| Project | IEEE 802.16 Broadband Wireless Access Working Group http://ieee802.org/16 > | | |
| Title | Procedures Clarifications and Improvement for MBS Logical Channel support in 802.16REV2 | | |
| Re: | P802.16Rev2/D4, LB26c | | |

Procedures Clarifications and Improvement for MBS Logical Channel support in 802.16REV2

Figure 10—Classification and CID mapping (BS to SS)

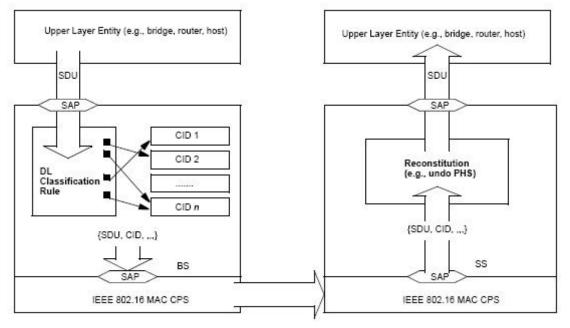
Classification is the process by which a MAC SDU is mapped onto a particular transport connection <u>or onto a</u> <u>particular logical channel within an MBS transport connection</u> for transmission between MAC peers. The mapping process associates a MAC SDU with a transport connection<u>or a logical channel of an MBS transport connection</u>, which also creates an association with the service flow characteristics of that connection. This process facilitates the delivery of MAC SDUs with the appropriate QoS constraints.

A classification rule is a set of matching criteria applied to each packet entering the IEEE 802.16 network. It consists of some protocol-specific packet matching criteria (destination IP address, for example), a classification rule priority, and a reference to a CID<u>and if applicable, to a Logical Channel ID of an MBS transport connection</u>. If a packet matches the specified packet matching criteria, it is then delivered to the SAP for delivery on the connection defined by the CID<u>or on the logical channel, defined by the Logical Channel ID of an MBS transport connection by the multicast CID</u>. Implementation of each specific classification capability (as, for example, IPv4 based classification) is optional. The service flow characteristics of the connection provide the QoS for that packet.

Several classification rules may each refer to the same service flow or in the case of an MBS service flow with separate contents identified by MBS Content IDs, to the same MBS content associated with an MBS Content ID. The classification rule priority is used for ordering the application of classification rules to packets. Explicit ordering is necessary because the patterns used by classification rules may overlap. The priority need not be unique, but care shall be taken within a classification rule priority to prevent ambiguity in classification. DL classification rules are applied by the BS to packets it is transmitting and UL classification rules are applied at the SS. Figure 10 and Figure 11 illustrate the mappings discussed in the previous paragraph based on the scenario when classification is applied to a CID.
